Access Compliance Report

Public Rights-of-Way

Intersection ID: 42769	Main Street: ERWIN_RIDGE_AV	Cross Street: JEANETTE_CR	Location: W
ADA ID: C915A8DA8AB6	Ramp Type: PerpDiag	Initial Pass/Fail: Fail	Overall Compliance: No
			Severity Score: 18.75

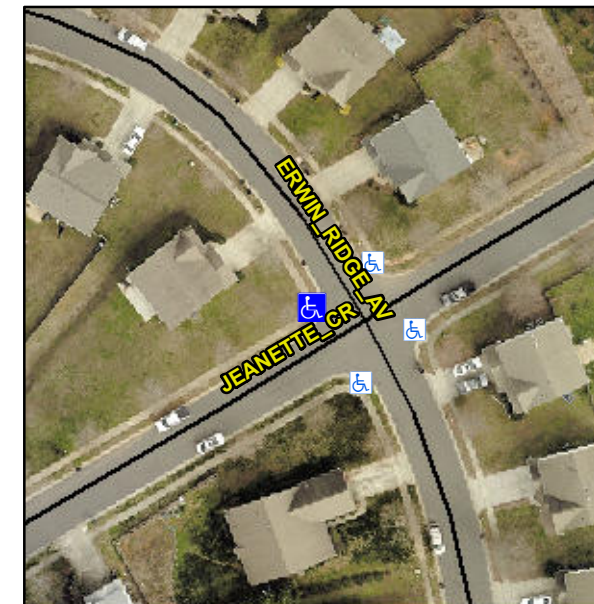
Not Found, R304.5.1, R304.5.3

Remove & Replace Curb Ramp With Two New Directional Ramps or Equivalent.
